**AGENDA
PLANNING COMMISSION MEETING
CITY OF SHOREVIEW**

**SHOREVIEW PLANNING COMMISSION
MEETING MINUTES
January 26, 2016**

SUBJECT: Case File 2602-16-01 Comprehensive Plan Amendment, Rezoning, Preliminary Plat, Planned Unit Development – Development Stage, Elevage Development Group, LLC/Elevage Shoreview Holdings, LLC

Proposed Elevage Development in Shoreview, MN shows Sun Shadow on homes to North & West of 5-Story Apartments

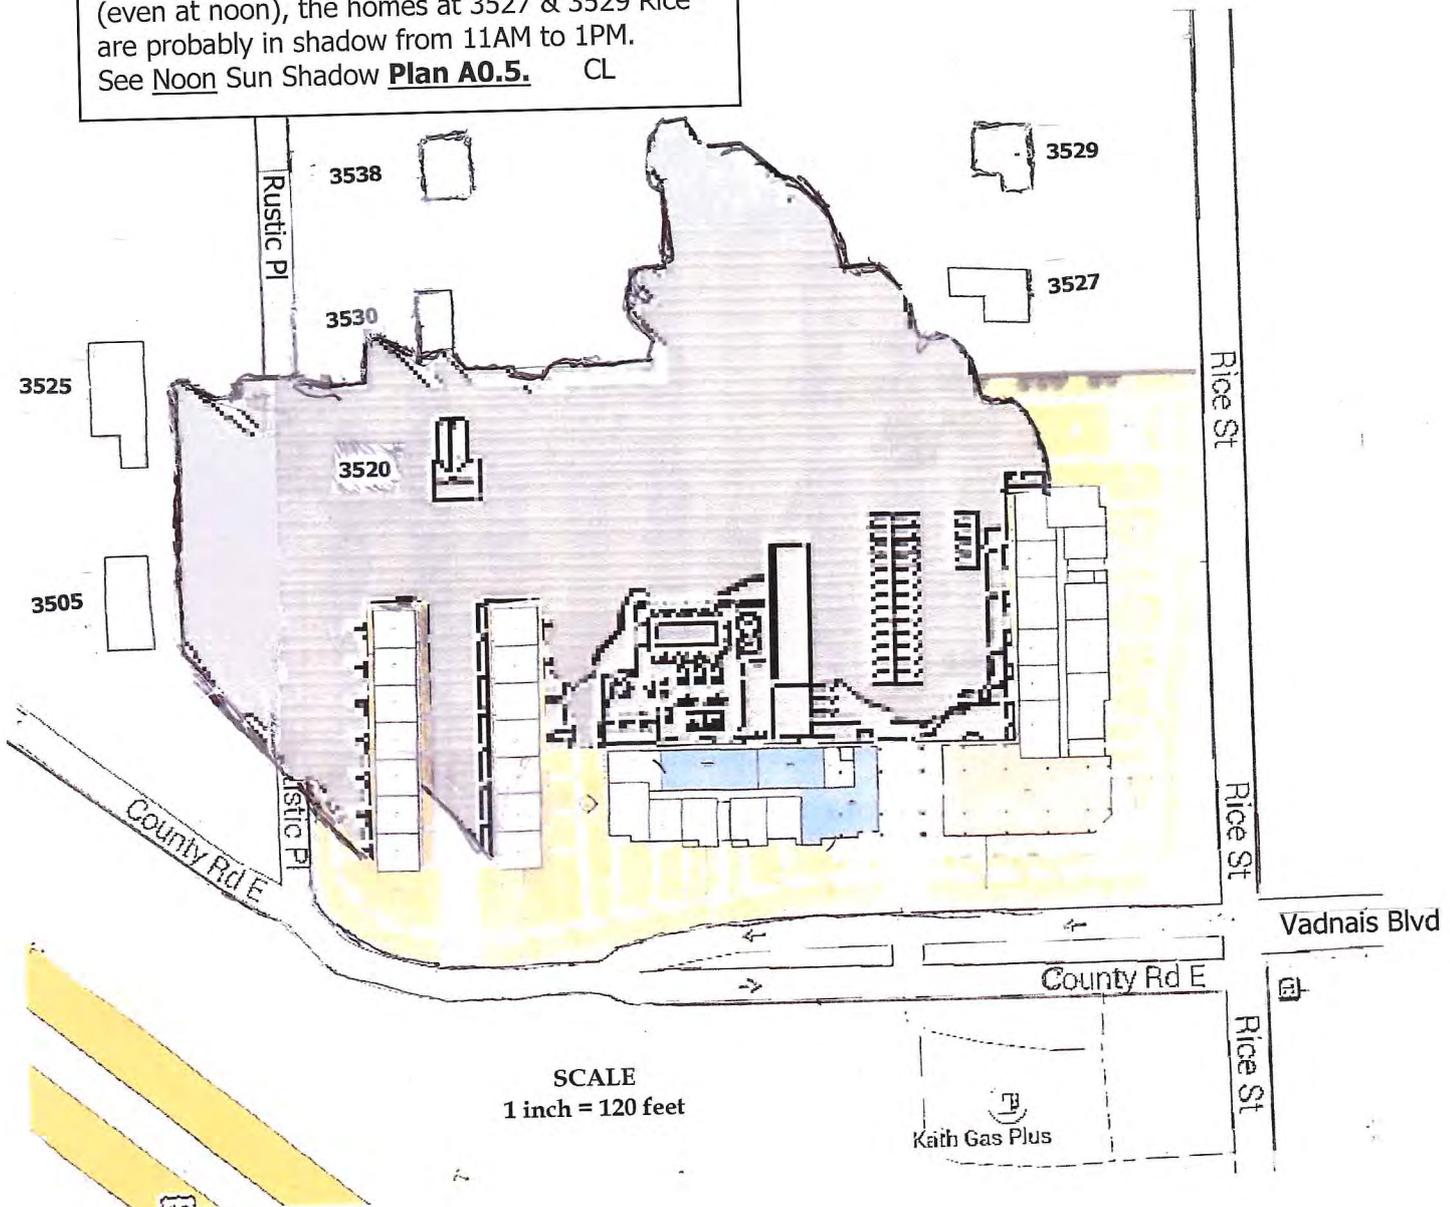
The proposed development would be between Rice St and Rustic Place North of County Rd E (on N. side of Freeway 694). Plans used in this drawing can be found at the Shoreview City website. Those plans from Commission agenda of 1-26-16 are:

- **A 0.5** - Sun- Shadow Dec 9 AM cast by proposed Apartments
- **A 1.1** - Plan View of the main development

Given how low the sun is in southern sky in Dec (even at noon), the homes at 3527 & 3529 Rice are probably in shadow from 11AM to 1PM. See Noon Sun Shadow Plan A0.5. CL
